PSE State Diagram Updates

Heath Stewart, David Stover

- Replace Figure 33–22 with the following:

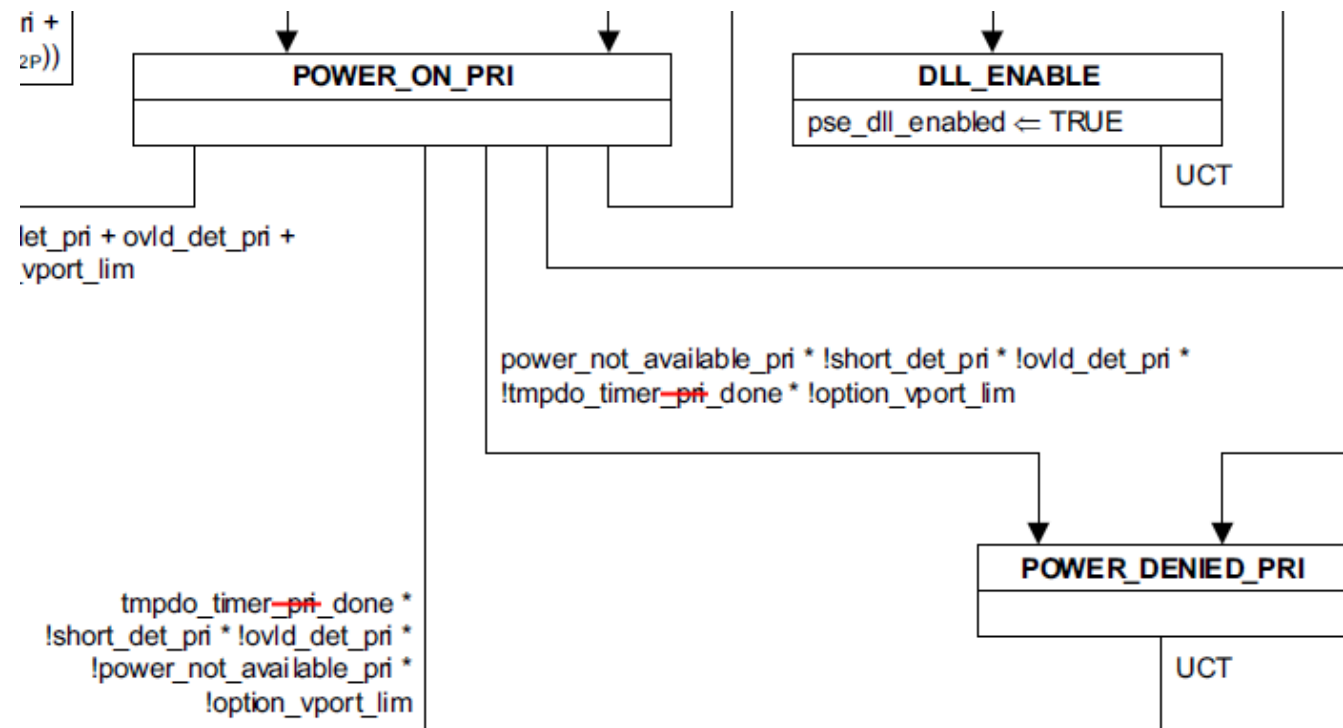
DC MPS – Observations

- Existing variable definition of `mr_mps_valid` encapsulates all defined methods for measuring I_{Hold} in MPS present/absent as defined in 33.2.10.1.2
 - 33.2.5.9 – Type 3 and Type 4 Variables
 - `mr_mps_valid`
 - The PSE monitors the Maintain Power Signature (MPS, see 33.2.10.1). This variable indicates the presence or absence of a valid MPS.
 - Values:
 - FALSE: MPS is absent.
 - TRUE: MPS is present.
- Only one MPS state diagram and MPS timer required to observe PSE MPS rules for one or both pairs powered (ie Main or SISIM state diagrams)

DC MPS – Proposed Solution

- Modify Figure 33–16:

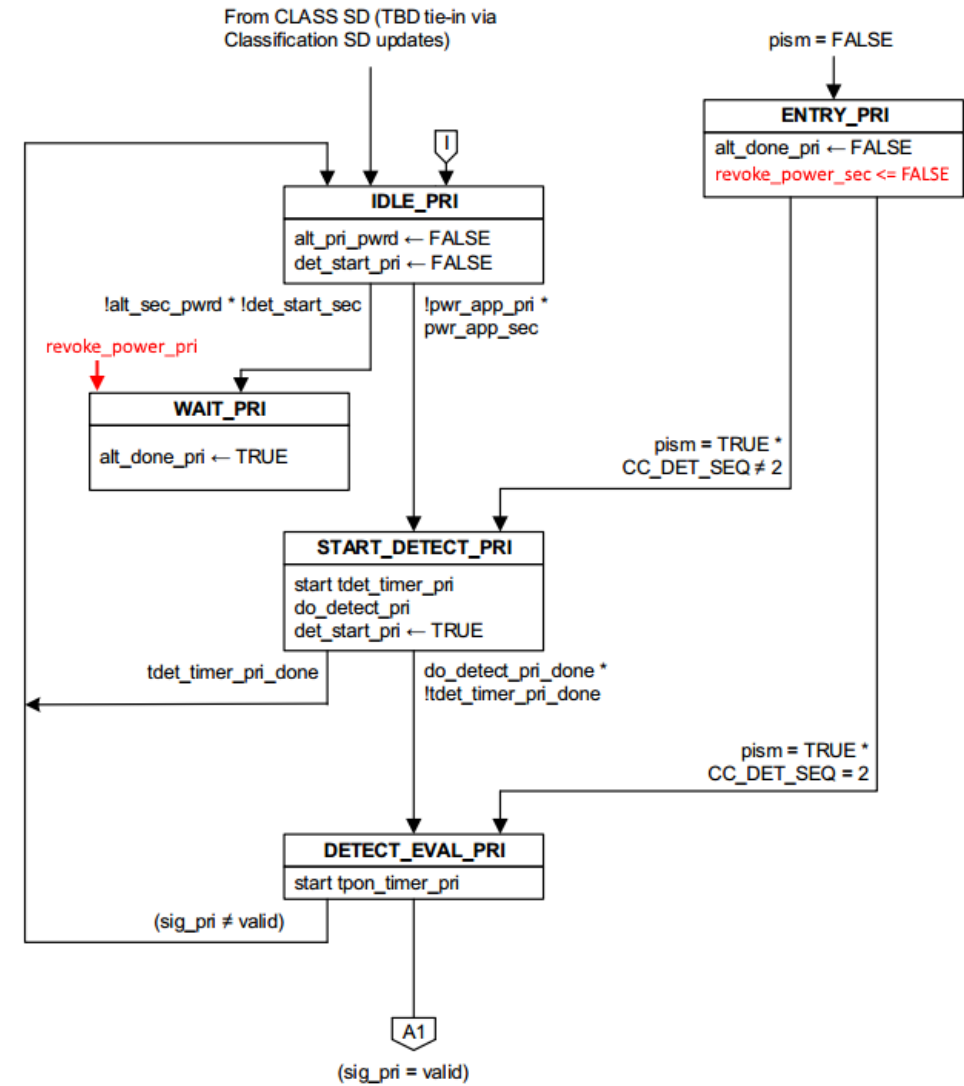
Optional Power Removal – Proposed Solution
